Review of VAB System

- Based on: -- Operator's Manual for TECO-Harmison H.L. machine model #104 - Thermo Electron Corporation.
-- Screening report VAB system TR 102-1-T0.001. 1 September 1972. Utah BTL.
-- Conversations with Frank Altieri.

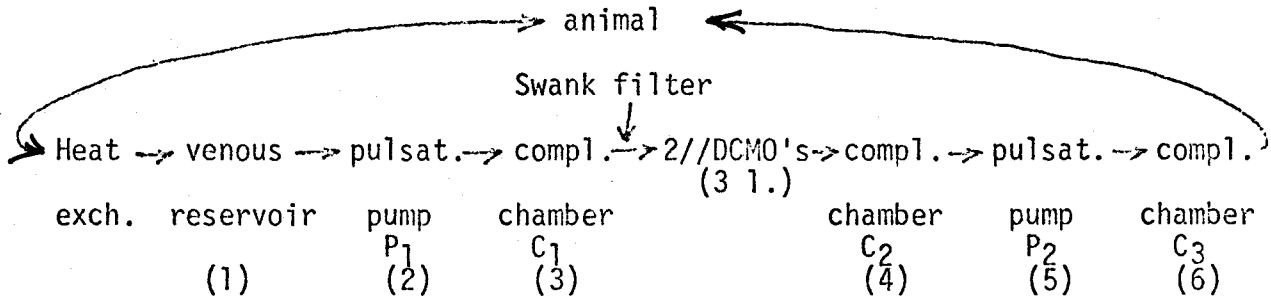
The pump design corresponds to the following schema:

It contains no less than six chambers through which the blood must circulate (not counting the heat exchanger and the DCMO's). These chambers are shaped in the form of cylindrical segments and are connected by means of much narrower circular conduits (Re - Operator's Manual figure IV-3): When circulated through the pump, the blood is therefore subjected to successive accelerations (in the conduits) and decelerations (in the chambers) with possible formation of jets and trauma to the constituents of the blood. The statement (UBTL p. 4-1), unsubstantiated by either data or references, that piston pumps may be gentler than rollers is difficult to understand in the light of this design.
